The KIT-A Conversion Package "**AC13A**" includes all the components of **Device #8** to meet current Chlorine Institute specifications.

PART# AC13B

CAP SCREW 8C1 (Replacing Cap Screw 8C)

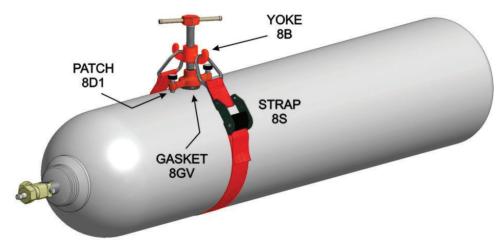
Designed to be "hand tightened" but accessible with the standard valve wrench as well
